Program Bulletin

CUSTOMER SATISFACTION PROGRAM

SUBJECT: Uneven Police Car Rear Tire Wear – Replace Rear Wheel Spindle Rods

MODELS: 2007-2008 Chevrolet Impala
Equipped with Police Package (RPO 9C1/9C3)

2129076

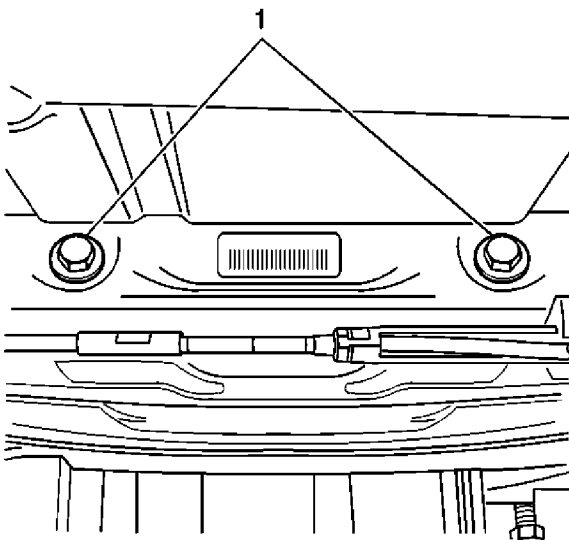
5. Remove the rear wheel spindle rod bolts (4) and nuts from the knuckles (both sides).
6. Remove the stabilizer shaft from the rear suspension support.
7. Support the rear suspension support with jack stands and remove the mounting bolts.
8. Lower the rear suspension support in order to gain access to the rear wheel spindle rod to support bolts.
